APPLICANT: Govenors Towne Square, LLC

PETITION NO: Z-5

PROPOSED USE: Bank And Retail

PLANNING COMMENTS: **Staff Member Responsible:** John P. Pederson, AICP

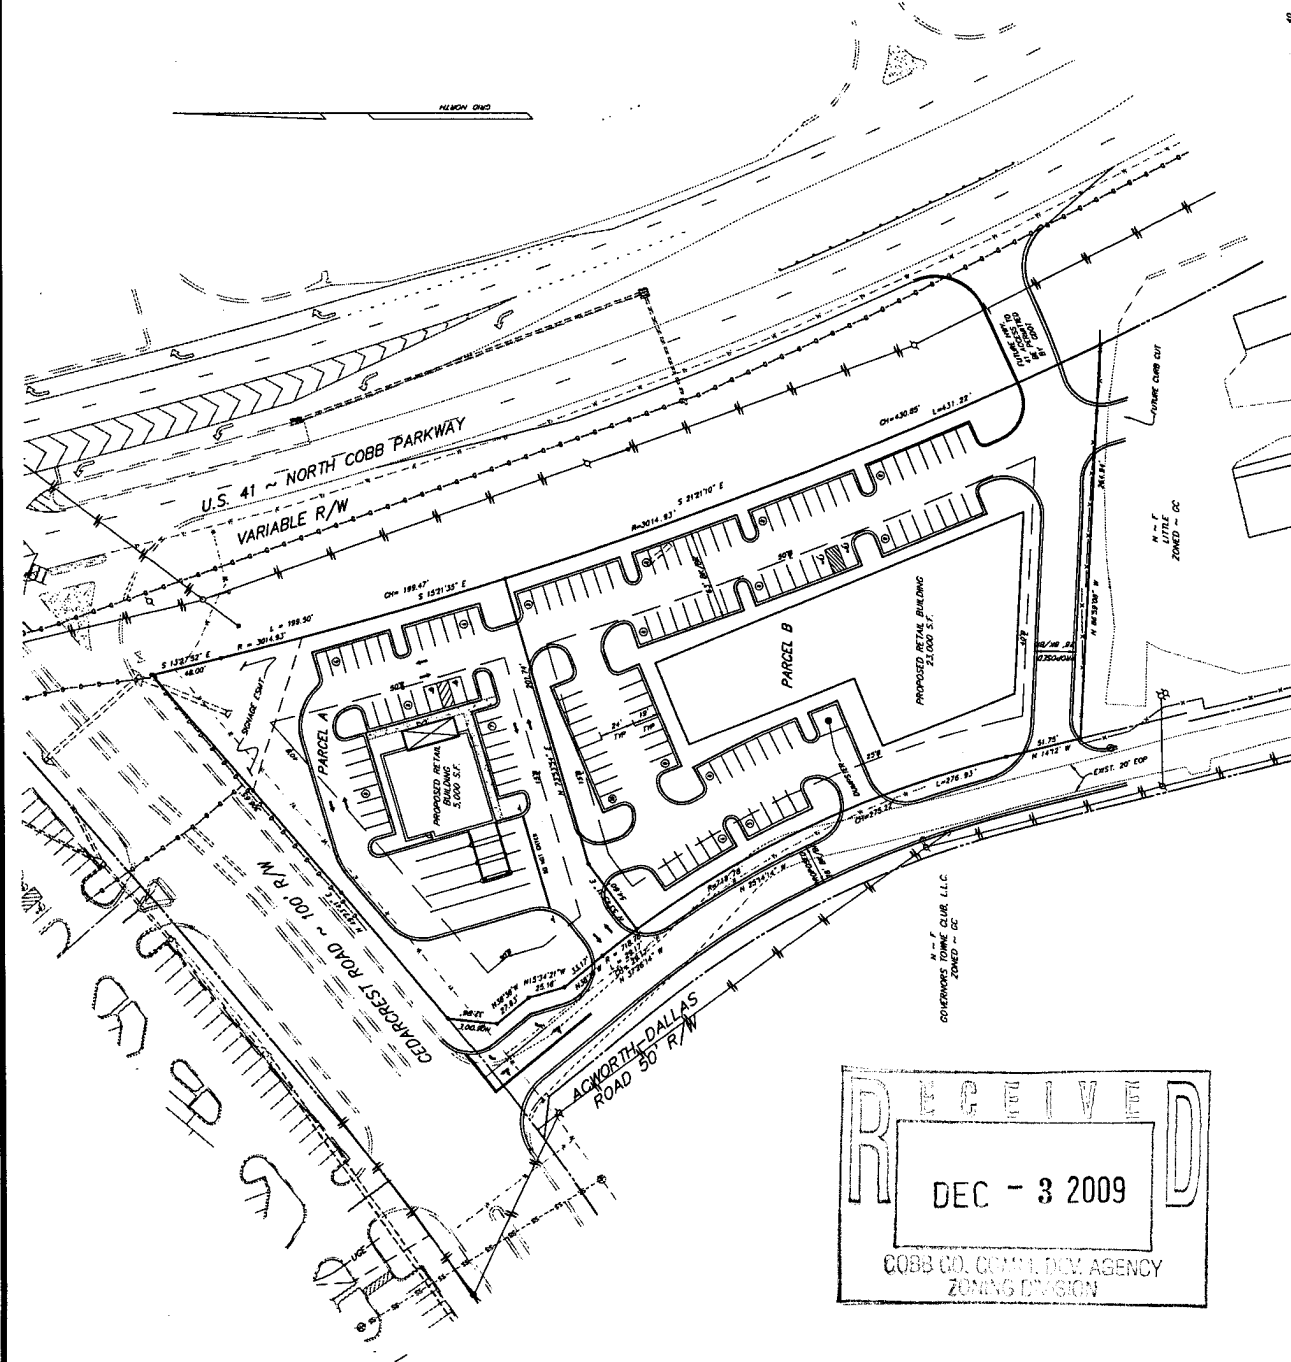
Acworth Dallas Road is not located as shown on the proposed plan. A right-of-way swap needs to be executed for the relocated Acworth Dallas Road.

Recommend right-of-way swap for Acworth Dallas Road right-of-way be completed.
